NVM Express® Technical Errata

Errata ID	114
Revision Date	6/26/2023
Affected Spec Ver.	NVM Express® Base Specification Revision 2.0c
Corrected Spec Ver.

Errata Overview

Figure 31 Discovery Controller Initialization process flow

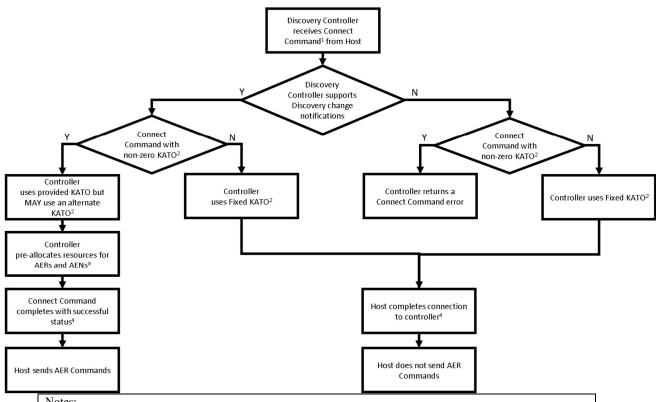
- Swapped footnote content on Figure 31: Discovery Controller Initialization process flow. Also, added note for superscripts (footnote references) to change to 14pt font in this table.

<Editor: please increase the font size of superscripts to 14pt>

- 1. Refer to section 6.3.
- <Editor: Note swapped footnote content>Refer to the Keep Alive command in section 5.18;
- Refer to the Asynchronous Event Request command in section 5.2; and
- Refer to the following steps in this section.
